MIDLAND PROJECT
DOCKET NO 50-329, 50-330
RESPONSE TO 10 CFR 50.54 REQUEST
ON DESIGN ADEQUACY OF B&W SYSTEMS
FILE: 0485.19 SERIAL: 8563

Enclosed are ten (10) copies of Consumers Power Company's response to your supplemental 10 CFR 50.54(f) request dated March 7, 1980 regarding B&W System Sensitivity.

RESPONSE TO 10 CFR 50.54(f)
SUPPLEMENT 1

FIGURE F.18-1

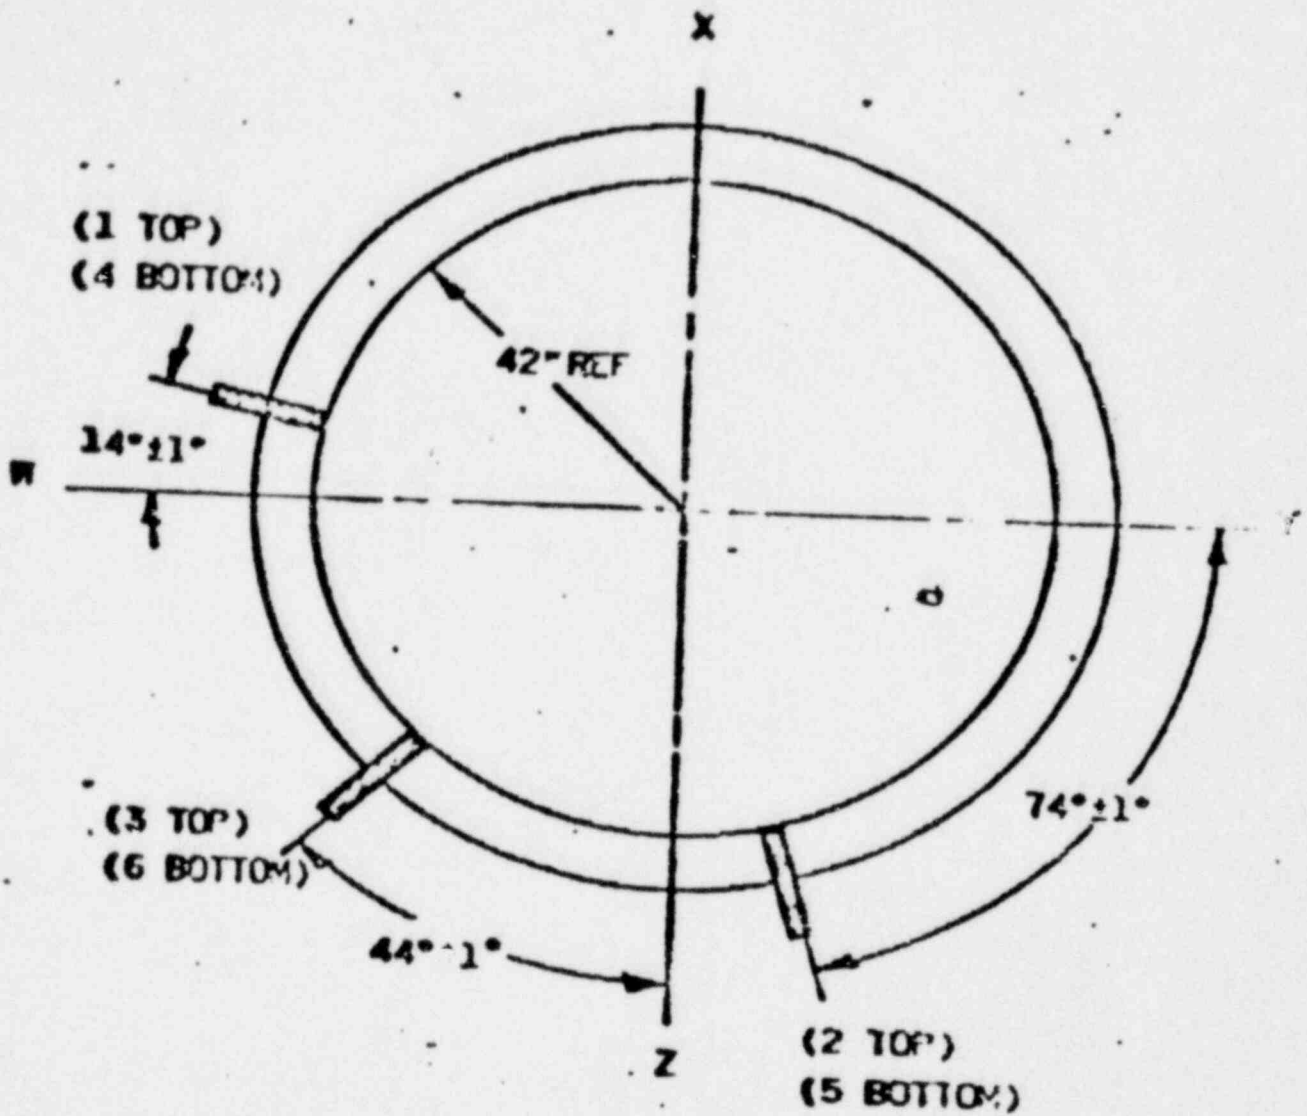
Regarding your proposed changes to the pressurizer level indication, specify the new location of the instrumentation taps and revise FSAR Figure 3.8-73 accordingly. Also provide or reference the relationship between "indicated" and "actual" level for the revised Midland design.

The Midland pressurizers will be modified to increase the indicated level range from 0-320 inches to 0-400 inches. Figures F.18.1 and F.18.2 show the azimuthal and elevation locations, respectively, of the three new high level sensing nozzles and the three new low level nozzles. Table F.18.1 is to be used in conjunction with Figure F.18.2 to define the location of each nozzle. Table F.18.2 provides the relationship between "indicated" pressurizer level and the "actual" water volume.
